SUBJECT: SEQUOYAH NUCLEAR PLANT, UNITS 1 AND 2 - ISSUANCE OF AMENDMENTS REGARDING ENHANCEMENT OF REACTOR COOLANT LEAKAGE DETECTION AND OPERATIONAL LEAKAGE CONSISTENT WITH STANDARD TECHNICAL SPECIFICATIONS (TAC NOS. MA6760 AND MA6761) (TS 98-10)

## AMENDMENT TO FACILITY OPERATING LICENSE

Amendment No. 259 License No. DPR-77

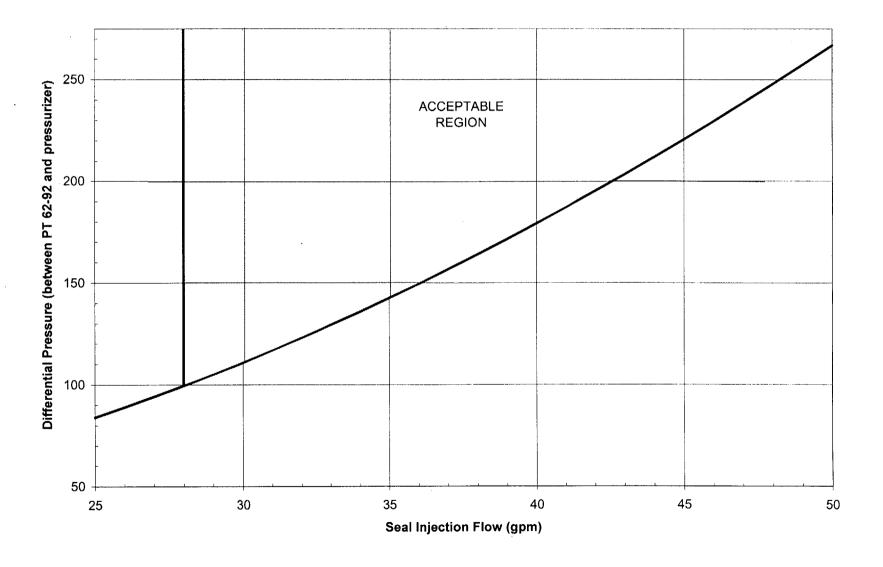
3.5.6 Reactor coolant pump seal injection flow shall be within the limits of Figure 3.5.6-1.

4.5.6 At least once per 31 days\* verify manual seal injection throttle valves are adjusted to give a flow within the emergency core cooling system safety analysis limits in Figure 3.5.6-1.

The staff has reviewed the proposed RCP seal injection flow limits (Figure 3.5.6-1) and concludes that these limits would provide a more conservative level of protection with respect to ECCS performance since they are developed based on the current TS value at normal operating RCS pressure. The staff has also reviewed the proposed TS 3.5.6 for RCP seal injection flow and concluded that the proposed changes are consistent with NUREG-1431, including the recommended allowable action times and surveillance intervals. The current TS requirements do not prescribe sufficient parameters to ensure that appropriate conditions are established to verify the seal injection flow resistance. The proposed revision will enhance this SR by establishing an RCP seal injection flow rate is within ECCS safety analysis limits. Hence the TS requirements will continue to maintain ECCS performance within the envelope of the safety analysis. Therefore, this change is acceptable because the current limits for RCP seal injection flow will continue to be maintained in accordance with existing requirements based on the safety analyses and plant operating procedures.

# FIGURE 3.5.6-1 Seal Injection Flow Limits

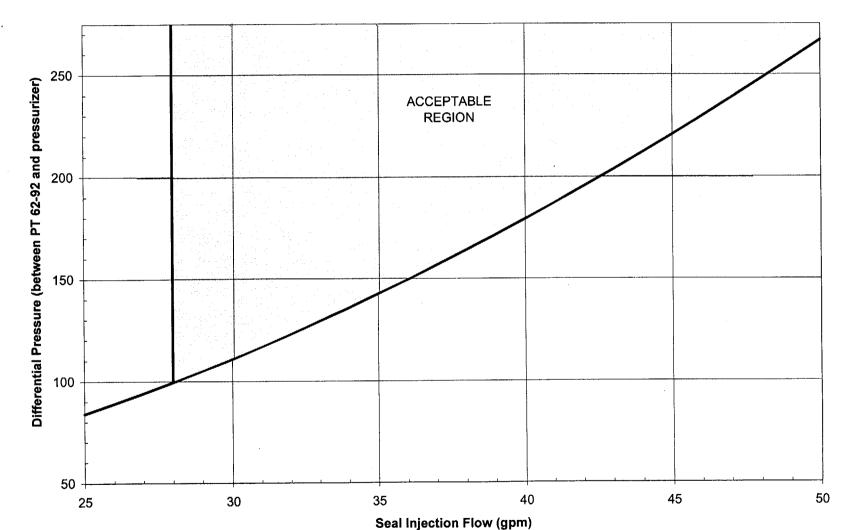
3.5.6 Reactor coolant pump seal injection flow shall be within the limits of Figure 3.5.6-1.

4.5.6 At least once per 31 days\* verify manual seal injection throttle valves are adjusted to give a flow within the emergency core cooling system safety analysis limits in Figure 3.5.6-1.

New TS 3.5.6 is being added to provide the requirements for the seal injection flow. This specification takes the place of the current requirements in the operational leakage specification for controlled leakage. The new specification is fashioned after NUREG-1431; however, a modification to the NUREG has been incorporated that utilizes a relationship involving the pressure differential between the charging pump discharge header and the RCS and total seal injection flow. This method for determining acceptable seal injection flows does not require the current provision to have the modulating valve fully open in consideration of the SQN design for the location of the header pressure sensor. The current flow limit of 40 gpm at normal RCS pressure is replaced by range of flow limits that correspond to this amount of flow restriction over various amounts of pressure differential between the header and the RCS.

The surveillance for Specification 3.5.6 will utilize this range of differential pressures and associated flow values to verify acceptable settings of the seal injection throttle valves. The figure that contains these relationships will be included in the new specification. A footnote, consistent with NUREG-1431, has been added to the surveillance that clarifies the need to be at normal RCS pressure and stabilized for 4 hours prior to the performance of the flow verification. This provision replaces the existing exception for Specification 4.0.4. This specification will apply in Modes 1, 2, and 3, which is a modification of the current requirement that includes Mode 4. As a result of this change, the action will only require a shutdown to Mode 4 within a total of 12 hours if inoperable seal injection flows cannot be corrected.
